The quite improbable extension of the Dili airport runway

December, 2018

The Government of East Timor announced on December 3rd, 2018, that the Dili Airport runway would be lengthened to 3,000 m and all traffic would be diverted during construction to Suai and Oecusse airports.

The sea bottom slope along the potential reclaimed runway, as per the 2008 survey

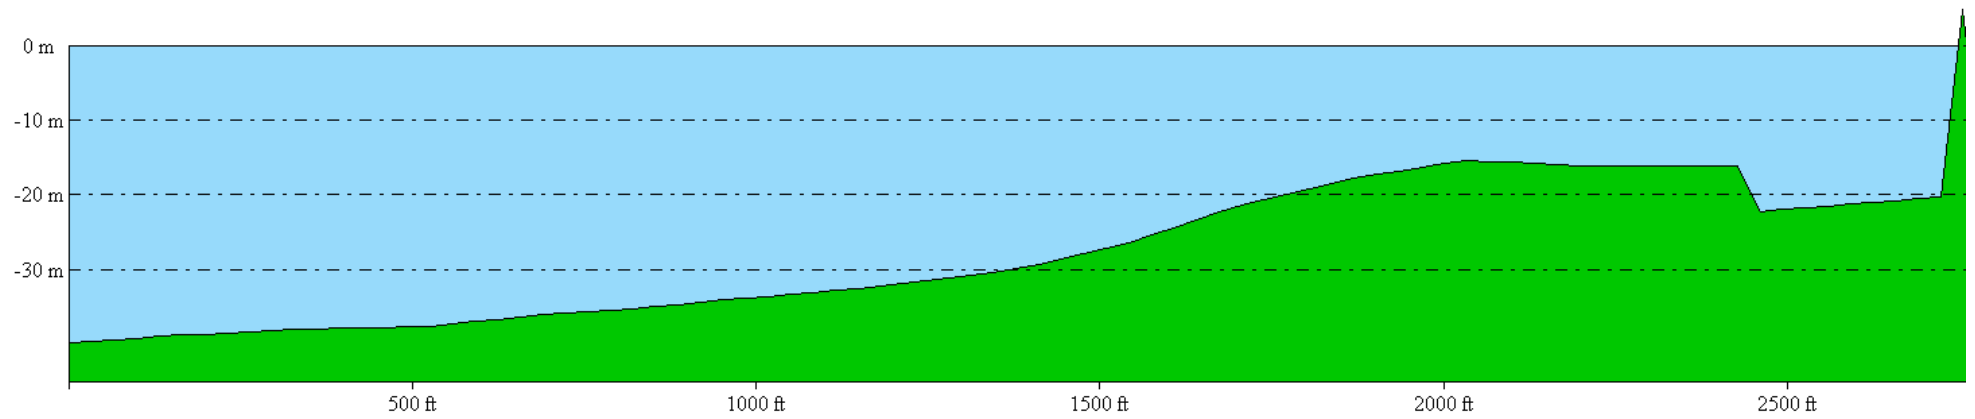
The author of this study personally surveyed the area for the government more than 10 years ago. The study was probably buried and the data lost.

Depth is 40 m, which would make reclamation a hugely expensive task, if at all feasible.
